Lake Geneva Utility Commission

LAKE GENEVA UTILITY COMMISSION MONDAY FEBRUARY 21, 2022 4:00 PM COUNCIL CHAMBERS - CITY HALL, 626 GENEVA STREET

RE: Lake Geneva Utility Commission
T-Mobile (ML70554A)
Host Composite Tank
Drawing Review #3

RE: Lake Geneva Utility Commission
T-Mobile (ML80166A)
Dodge Spheroid Tank
Drawing Review #2

C-2
EXISTING & NEW SITE PLANS

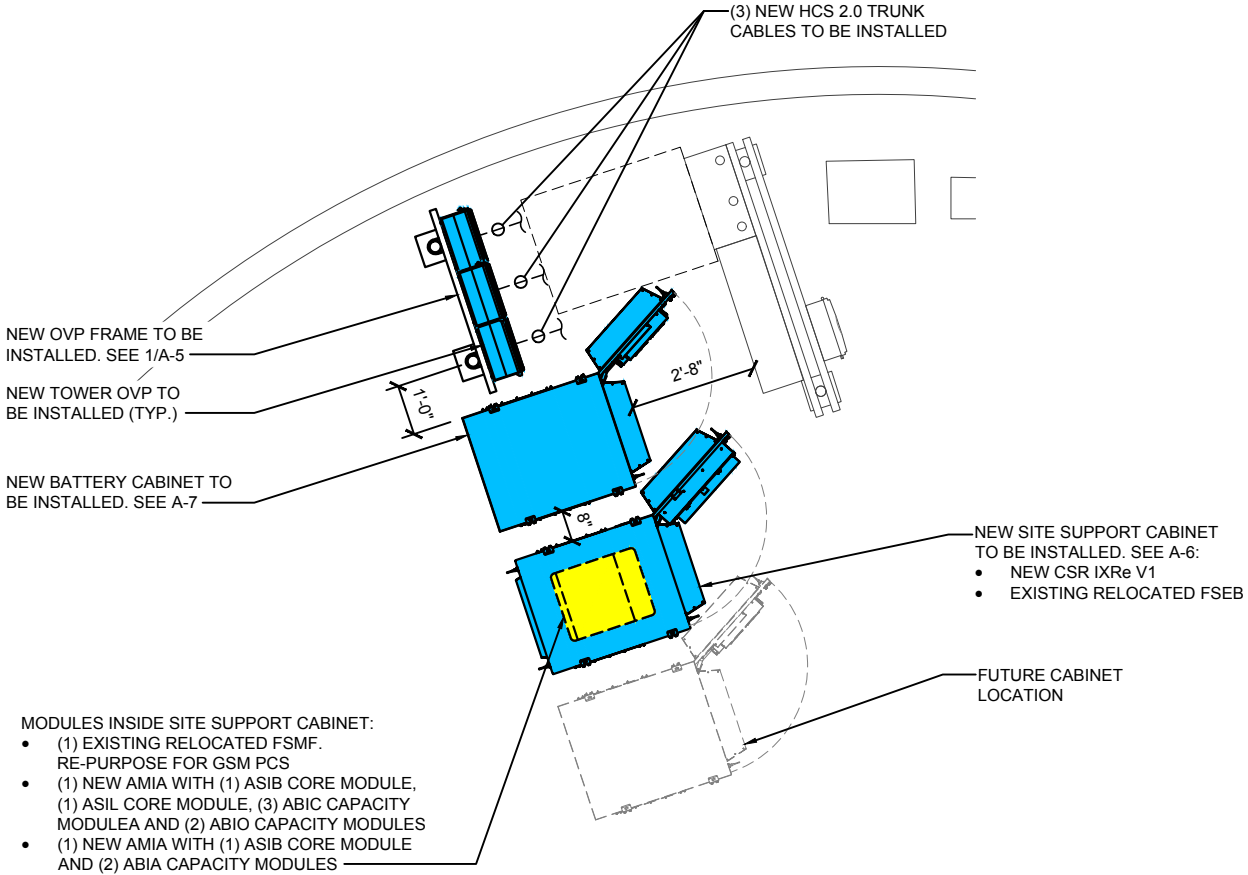
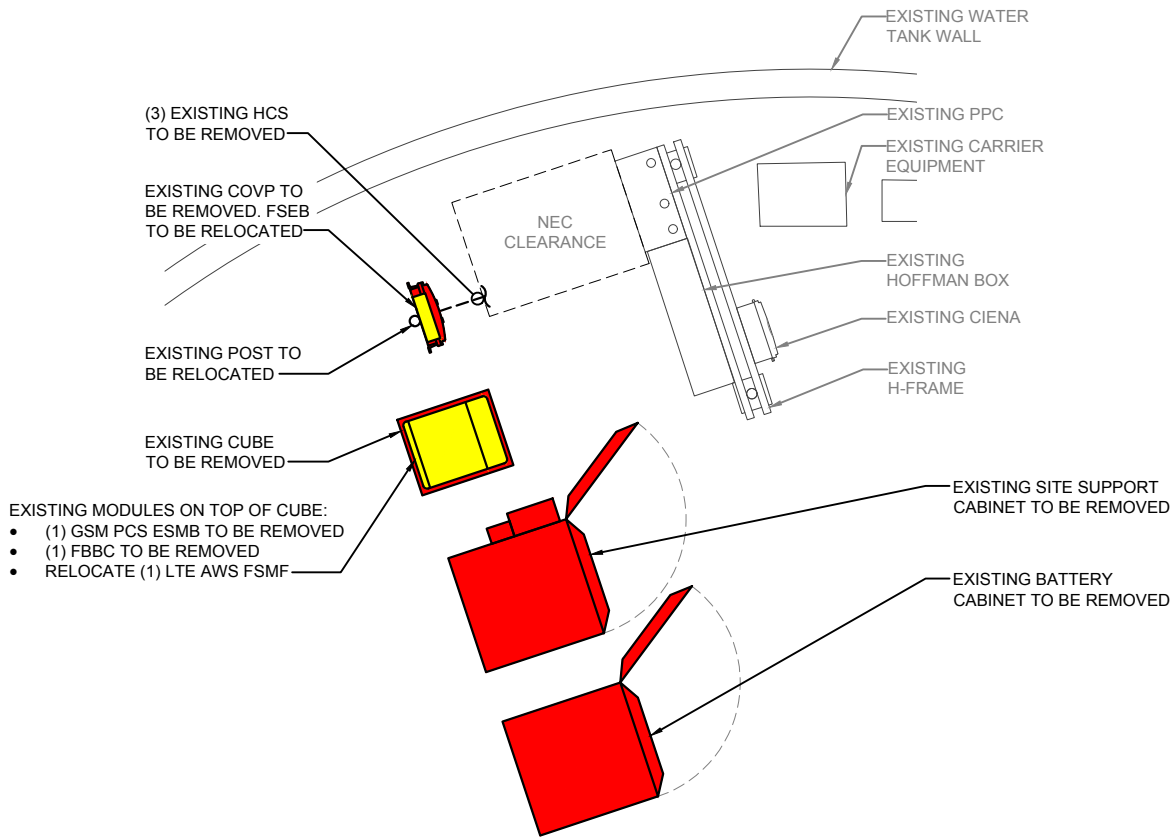
- B. I do not see an updated structural mount analysis for the tank. The approved version I am aware of is dated January 7, 2022. The reference to this document on Sheet A-1 in the design drawings was changed from 01/07/2022 to 02/01/2022. This needs to be changed back from 02/01/2022 to 01/07/2022.

- C. The email response said the only change to the updated design drawings was they went from (2) HCS 2.0 lines to (3) HCS 2.0 lines. DIXON does not see any issue with this change. The only location in the design drawings that I see this was not updated is on Sheet A-1. There is the note with the arrow just to the left of the concrete column that still says (2) new HCS 2.0 trunks that needs to be changed to (3).

There are two minor revisions required in the design drawings and they are both on Sheet A-1. I do not need to see a response letter to show these two items are addressed, but I will check them and provide a final approval letter/email.
